STAFF RECOMMENDATION

703 Shelby Avenue

August 19, 2020

Description of Project: The request is to paint the historic brick.

Figure 2. Staining to the left of the front porch.

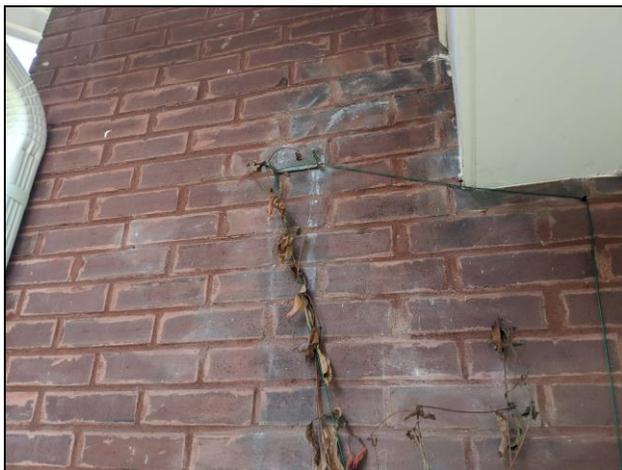
Painting of Masonry: The applicant has requested to paint the historic brick in order to cover existing stains as well as brick and mortar in need of repair. The stained areas are located near the front corners of the house and appear to be where the gutters were previously located (Figures 2 and 3).

The owner has suggested that the brick may have previously been painted or stained, but staff's inspection of the brick was unable to conclude that that is the case with the exception of the rear wall that was painted more recently without a permit. Some of the bricks appear either to have been damaged or worn down by recent or previous cleaning attempts or to have been stained by mortar in previous repointing efforts (Figures 4 and 5). (Also see Attachment B for more photos.) Staff also observed some individual brick that need repair. The owner has attempted to clean the brick using paint thinner, acetone, a wire brush, and multiple power washes, which are not effective or appropriate methods for cleaning historic brick.

Section II.B.5.c.3 of the Edgefield design guidelines states that the use of paint or stain on brick is not appropriate and that “if brick is so deteriorated that it cannot withstand the weather, a water repellent or paint may be appropriate.” Staff finds that the evidence does not meet the criteria for when painting brick could be appropriate. Instead, staff recommends that the mortar be repointed and brick be repaired, as needed. If additional cleaning is desired by the applicant, staff recommends a gentle alkaline chemical cleaner or poultice such as those made by Prosoco. The appropriate cleaner should be determined by testing different products as different types of masonry and staining have different requirements that can only be determined by testing. [Contractors trained to use Prosoco products](#) can assist with determining the appropriate product but other products are also available. More information is available through the National Park Service’s [Preservation Brief: Assessing Cleaning and Water-Repellent Treatments for Historic Masonry Buildings](#).

Recommendation: Staff recommends disapproval of the request to paint the brick, finding that the project does not meet Section II.B.5.c of the *Edgefield Historic Zoning District: Handbook and Design Guidelines* for when it is appropriate to paint brick. Staff recommends that the mortar be repointed and the masonry be repaired as needed using products and methods appropriate for historic masonry to prevent further damage.

Attachment B: Photos

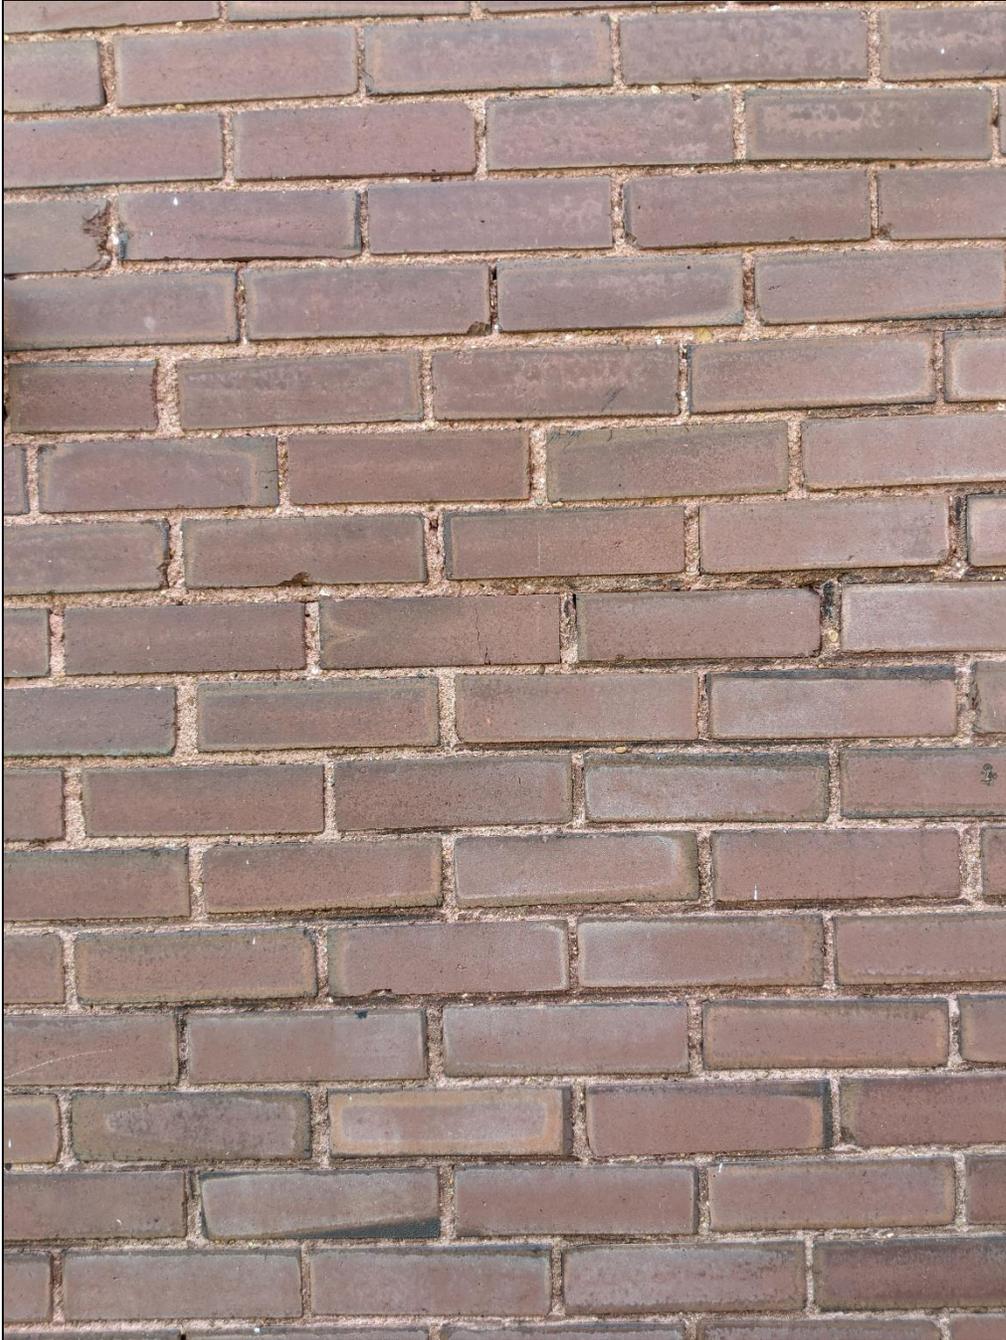
As stated previously, the rear façade has recently been painted without a preservation permit (Figure 6). While painting the brick does not meet the design guidelines, staff finds that leaving the rear wall painted could be appropriate since the rear façade is not visible from the street.
